**Re: Omaroro Reservoir – Request for Variation to Licence Agreement**

Thank you for the application Wellington Water Limited has made pursuant to Licence Condition LC.6 of the Omaroro Licence agreement for the following works:

# Attachment 1: Locations of Variation Areas

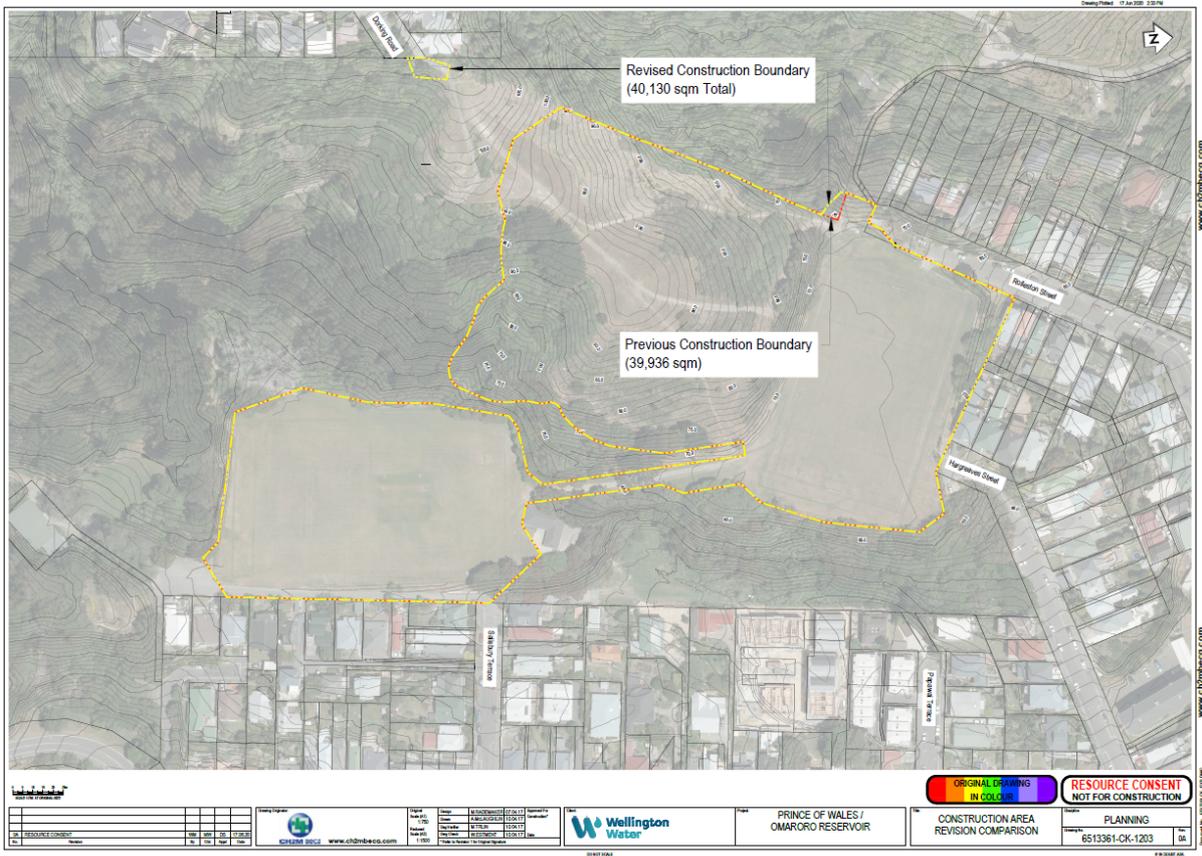
These proposed works would change the licence area in two locations, including the top of Dorking Road and the top of Rolleston Street. These two areas are shown in **Attachment 1**.

**Mitigation and off-setting for the variation shall include:**

- **Access via Dorking Road not to be allowed during the construction of the Reservoir project.**
- **Implementation of a tree protection for the Totara tree on Dorking Road and planting in the area of Town Belt and Road reserve**

- **Additional planting along the edges of the Waitangi Stream tributary**
- **Implementation of mitigation and erosion and sediment control measures to ensure protection of the tributary of the Waitangi Stream.**
